CITY OF CALGARY
CORPORATE PLANNING APPLICATIONS GROUP
REVISED PLANS
THESE PLANS REFER TO DEVELOPMENT PERMIT NO. 1796-1671
ONLY THOSE REVISIONS SHOWN IN RED FORM PART OF THIS DEVELOPMENT PERMIT
JUL 12 2006
DATE
DEVELOPMENT AUTHORITY

SIGNAL HILL VILLAS
303 SIGNAL HILL CIRCLE SW, CALGARY
INTRAWEST CORPORATION

DRAWING TITLE
SITE PLAN
LANDSCAPE PLAN
& DETAILS

DRAWING NUMBER
A1.0

1 SITE PLAN SCALE: 1:300

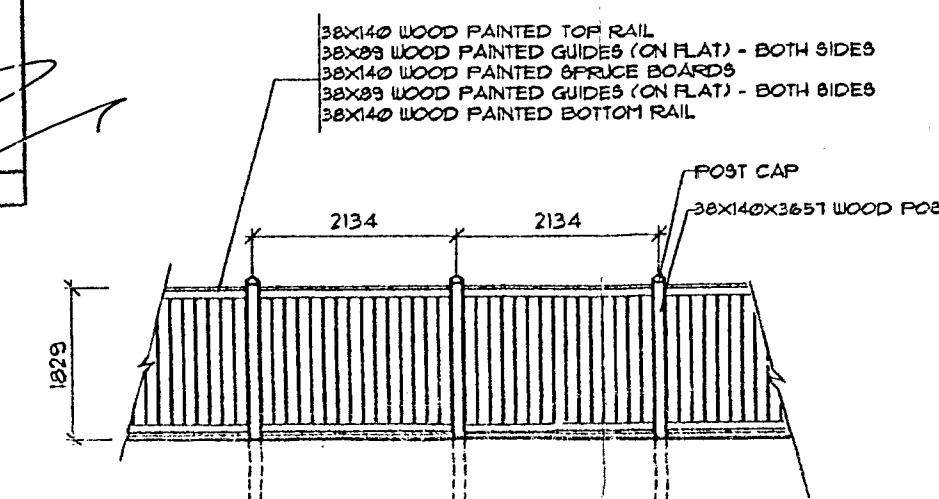
EXTENSION OF REAR DECKS TO A LENGTH OF 3.07 M (10 FT) 8 UNITS

REVISED AS PER REQUEST OF FIRE DEPT & BLOS. REG (ACCESS ROAD MAX 90m) 2 TREES ADDED. EUP STALLS REMOVED
